Access Compliance Report

Public Rights-of-Way

(Island Curb Cuts)

Intersection ID: 54269	Main Street: JOHNSTON_OEHLER_RD	Cross Street: OEHLER_BRIDGE_DR	Location: N
ADA ID: FEB9F61EBC89	Curb Cut Type: MedianRefuge2	Initial Pass/Fail: Fail	Overall Compliance: No
Severity Score: 1.25			
Codes/Mitigation Info/Possible Solution		Field Measurements/Component Compliance

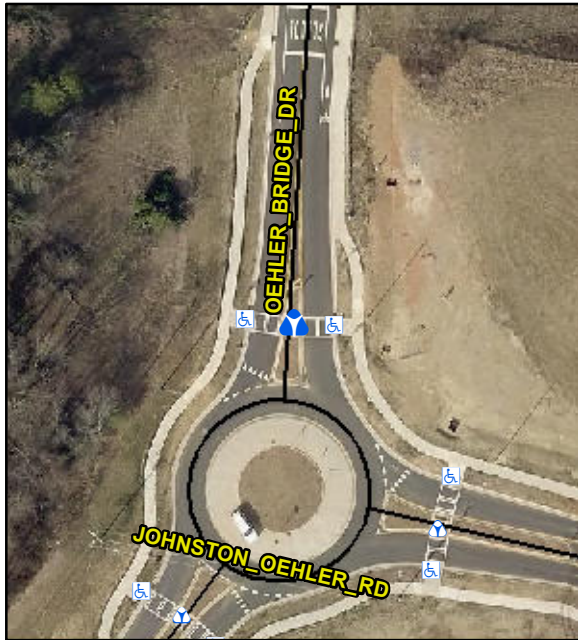
Remove & Replace Entire Refuge.
